**METROPOLITAN DEVELOPMENT COMMISSION
REGIONAL CENTER HEARING EXAMINER**

STAFF REPORTS FOR NOVEMBER 10, 2022

Case Number	2022-REG-065
Address (approx.)	1255 North Senate Avenue
Location	Center Township, Council District # 11
Petitioner	Indiana University Health, Inc., by J. Murray Clark
Zoning	CBD-S (RC)
Request	Regional Center Approval for provide for the construction of a central utility plant, a two-story, precast concrete building with metal panels, brick, and granite features, which would provide services to a hospital campus via underground utility system. The request would provide for a service area within the front yard of 13 th Street, a surface parking area for employees and frontage landscaping. The request would also provide for the demolition of a portion of an existing building and surface parking lot.

Case Number	2022-REG-066
Address (approx.)	2176, 2204 and 2220 North Meridian Street and 17 West 22 nd Street
Location	Center Township, Council District # 11
Petitioner	M22 Housing LP, by Scott Perkins, AIA
Zoning	MU-2 (RC)
Request	Regional Center Approval to provide for updated plans for a transit-oriented mixed-use development, previously approved through 2020-REG-

Landscape plan

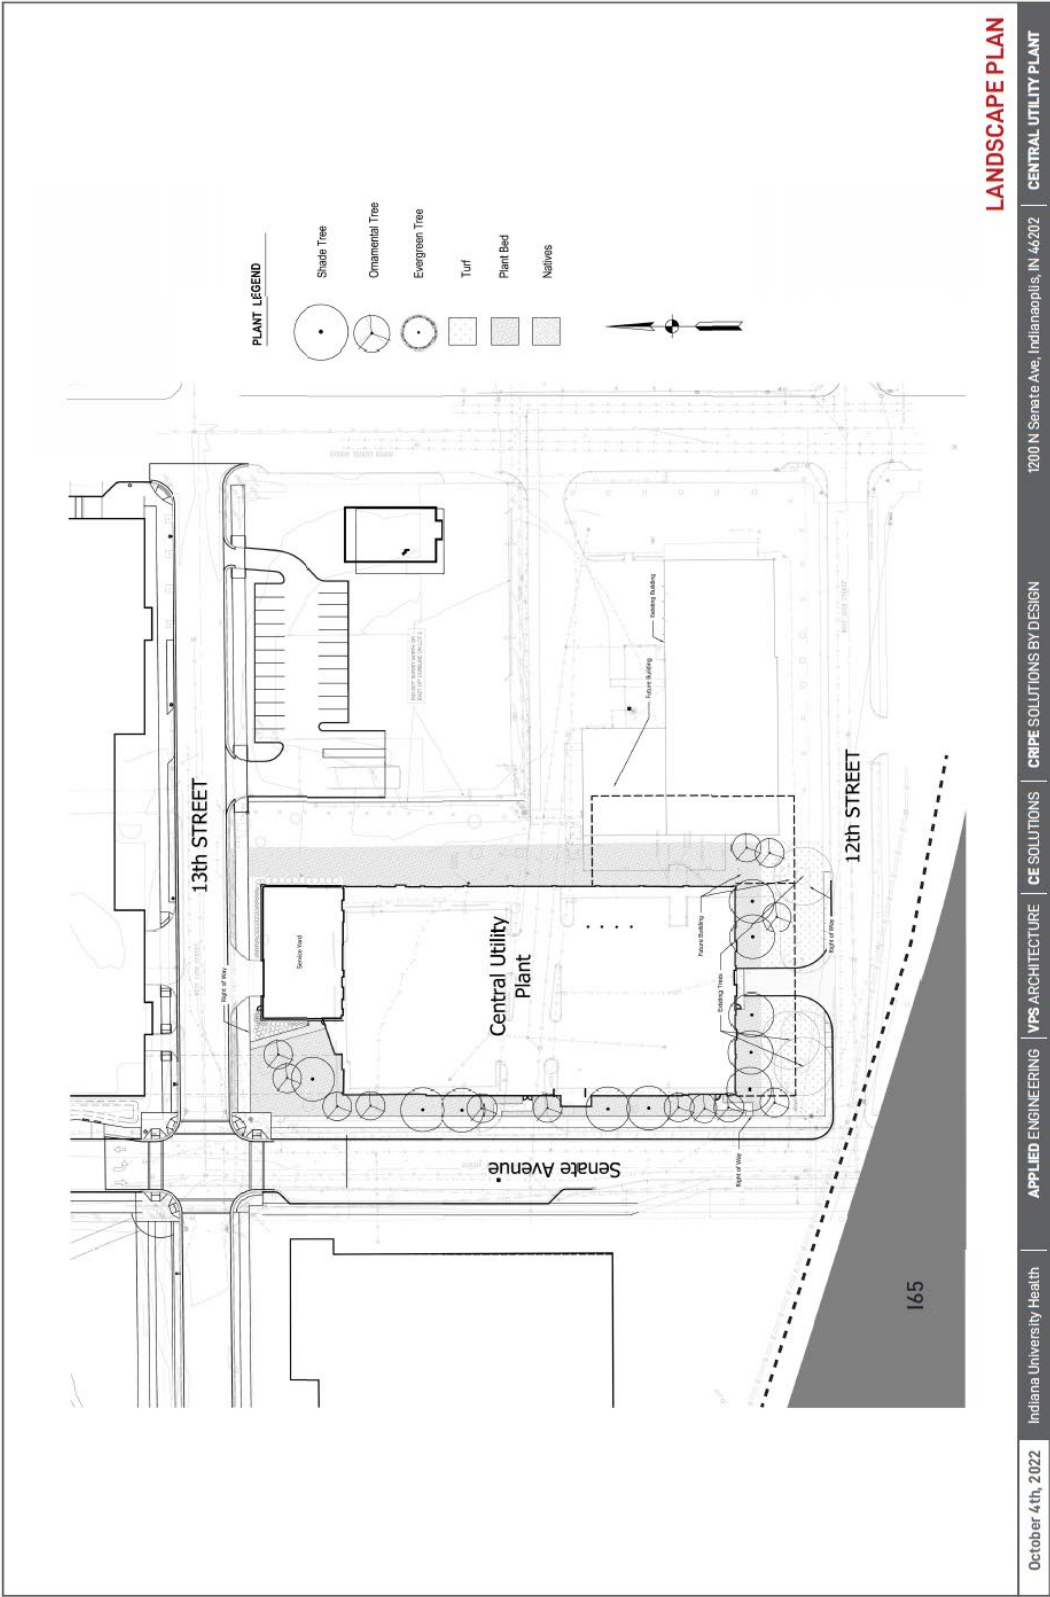
1. While a landscape plan has been submitted, it does not detail plant species. Staff requests that detailed landscaping plan be submitted and subject to planning staff review and approval, prior to installation. (Guidelines CA 4.6.1, CA 4.6.4, CA 4.6.5, and CA 4.6.7 apply).

SITE PLAN - BLDG 1

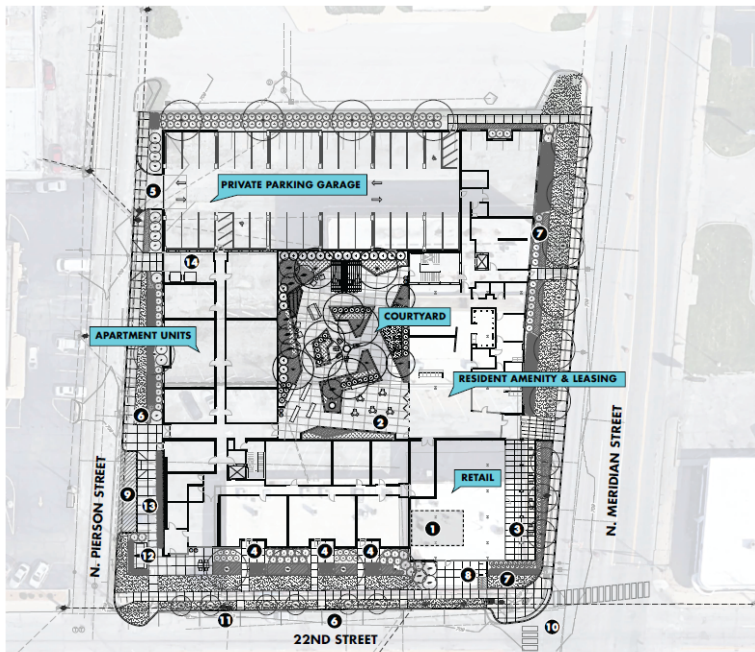
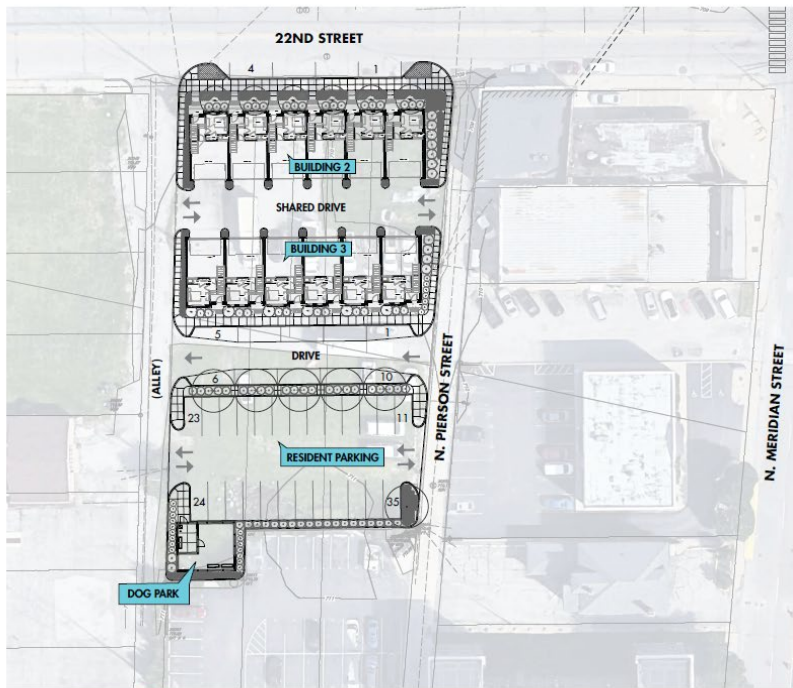
1. A scaled and detailed landscape plan was not submitted with this petition. A landscape plan shall be submitted for planning staff review and approval prior to installation and be subject to Guidelines US 1.3.2, CA 4.6.1, CA 4.6.4, and CA 4.6.7.
2. A lighting plan was not submitted to the file to identify the location of lighting standards or fixtures. Additionally, a photometric plan has not been submitted
